Service Manual

NISSAN Motor Genuine
2DIN HDD Navigation

Model UQY7813
(N# 25915 ZQ39A)
(MODEL No. NAU-3221KUS-V)

The original model of UQY7813/4/5/6,UQY7823/4/5/6 is UQY6102. This additional service manual is designed to be used together with the service manual of UQY6102.

Drawing-30

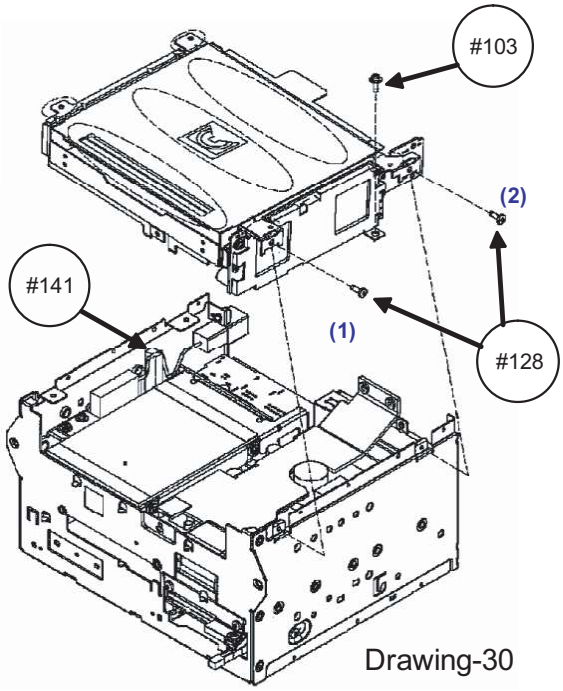
Please confirm it about the additional part (#141) in the following ASSEMBLY DRAWING and ASSEMBLY PROCEDUER.

PAGE	NO.	PART NO.	DESCRIPTION	QT'Y
5	#104	UCZ0851	HDD for UQY7816 / UQY7826	1
6	#112	.8829036C	AUDIO PWB AS	1
	#114	.9900403A	NAU-US-V2 PWB	1
10	#141	MUZ1971	ANT sheet (add)	1
	#127	MQZ0321	HDD2 sheet	1
11	#130	.8829012A	XM-PWB-Assy for UQY7823/4/5/6	1
	#131	----------	NU	-
	#135	MQZ0103	TUN sheet	1

PROCEDURE	NOTICE
3.Stick the(#141)ANT sheet on the processed AUDIO PWB ASSY (Drawing-30) and lay out GPS-ANT cable.	※Through the SHEET ANT upper part. (Drawing-24)
